# Vision Garments Ltd (New Building)

B-47, Purbo Rajashan, Savar, Dhaka.

25-Sep-2023

# Observations

**Storage live load limit not comply BNBC requirement**

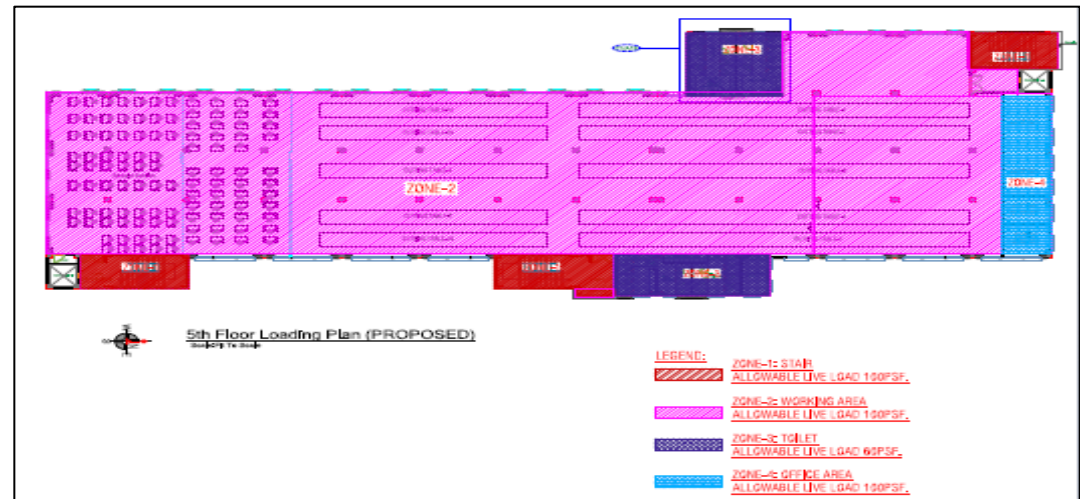
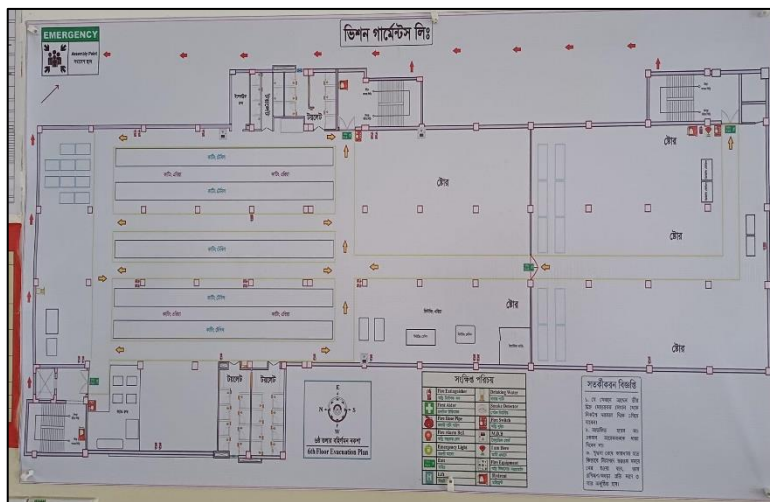
Storage area in 5<sup>th</sup> Floor

Prepared load plan for 5<sup>th</sup> floors. Floor loading has been considered 5kPa (100 psf) instead of 6kPa (125 psf) for storage areas.

As per BNBC, 6 kPa is required to consider as floor loading for the light storage facilities. During inspection, load plan was found posted considering (100 psf) 5kPa at 5<sup>th</sup> floor storage area. Also, 5 kPa live load considered in the software-based structural analysis. However, update the storage live load limit as per BNBC requirement, revise the structural analysis & design accordingly.

| Item No. | Observation                                                           | Recommended Action Plan                                                                                                                                                                                                     | Recommended Timeline |
|----------|-----------------------------------------------------------------------|-----------------------------------------------------------------------------------------------------------------------------------------------------------------------------------------------------------------------------|----------------------|
| 01       | Storage live load limit not comply BNBC requirement (New building-1)  | Revise storage live load limit as per BNBC requirement, update floor load plan and incorporate the changes in the structural analysis and design report. Design report shall be revised based on in situ concrete strength. | 6-weeks              |

# Mismatch in as-built drawings

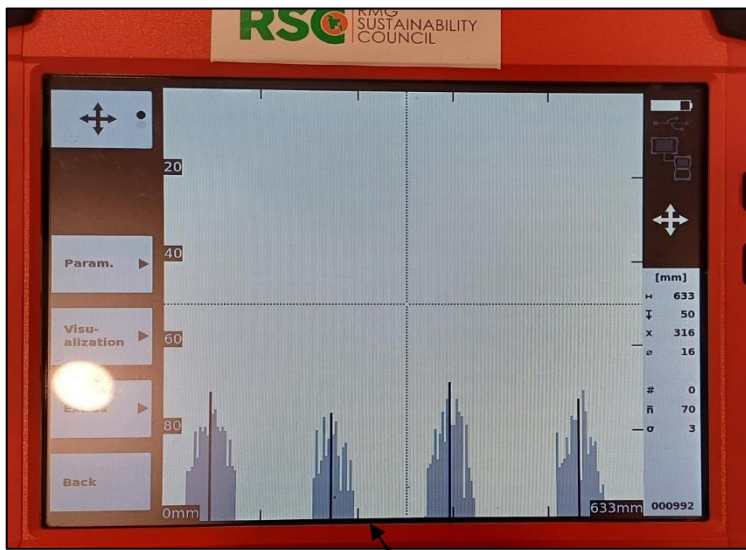
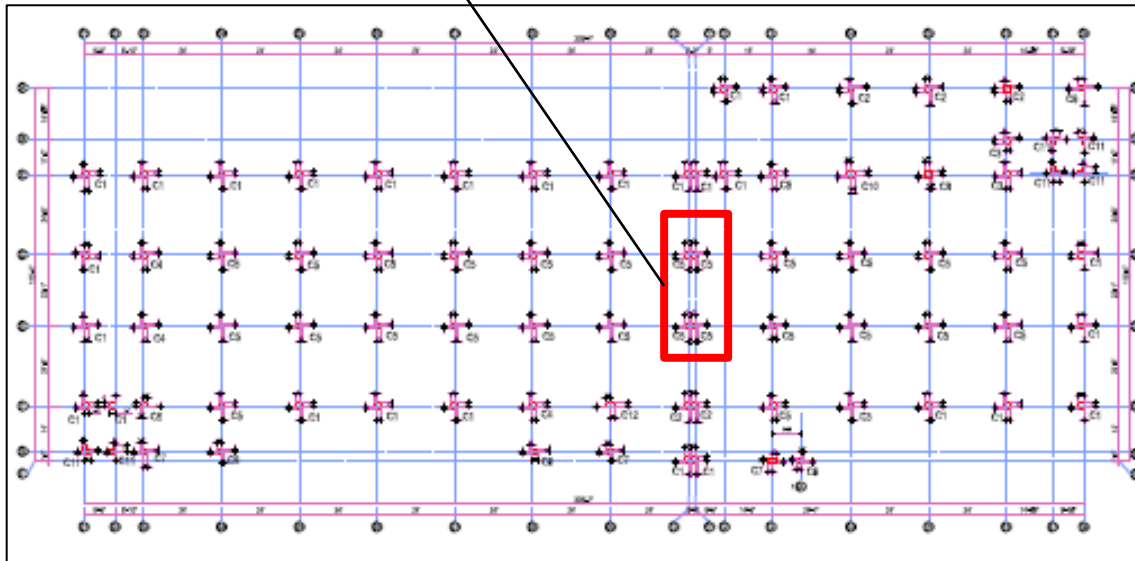
4 no's rebar each side at column C5

Column schedule: Column rebar 5 no's each side

Column layout plan

Building engineer is required to survey the whole structure, update the as-built drawings and perform Engineering Assessment (EA)

**Lack of lateral stability**

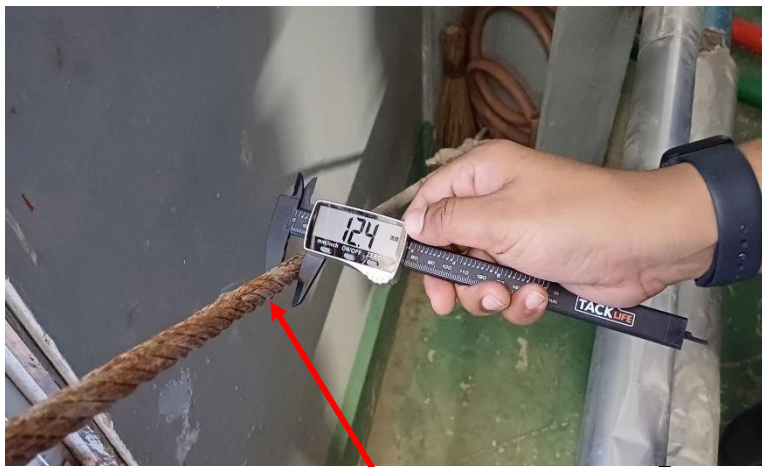
Horizontal compression members are not provided along long direction

load transfer media is not provided from frame to frame to transfer the lateral load at top at all sides. Hence, lateral stability system of structure is incomplete. The building engineer is required to check the lateral stability of the structure as part of EA and suggest proper remedial actions accordingly.

| Item No. | Observation                                                          | Recommended Action Plan                                                                                                 | Recommended Timeline |
|----------|----------------------------------------------------------------------|-------------------------------------------------------------------------------------------------------------------------|----------------------|
| 10       | Lack of lateral stability (Boiler Shed)                              | Building engineer is required to prepare a set of design documents in compliance with BNBC.                             | 6-weeks              |

## **Mismatch in as-built drawings**

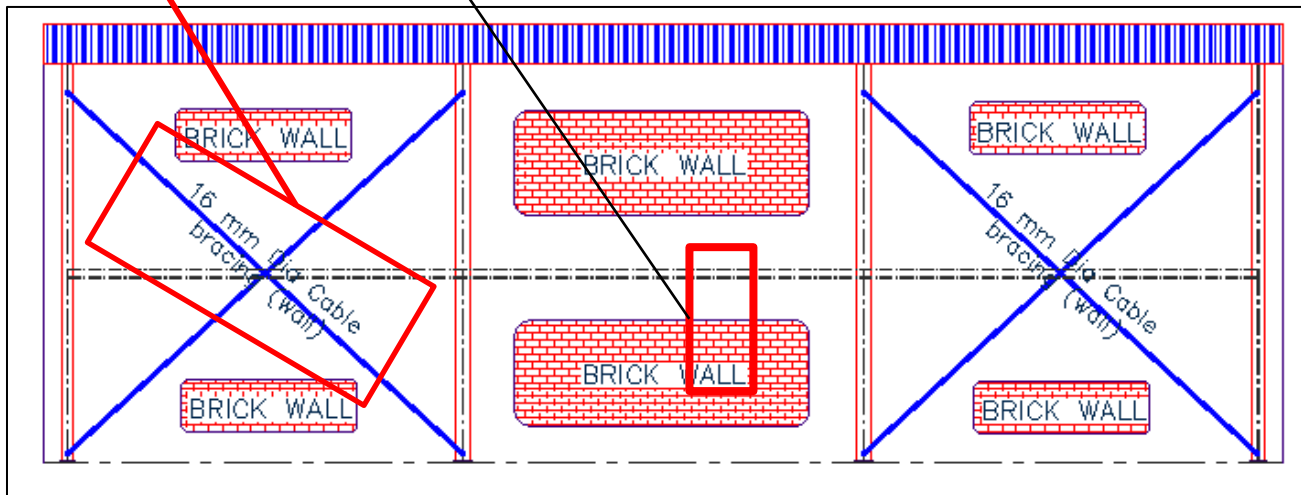
Wall bracing size 12.4 mm

Wall bracing

Wall bracing

Building engineer is required to survey the whole structure and update the as-built drawings as per site condition.
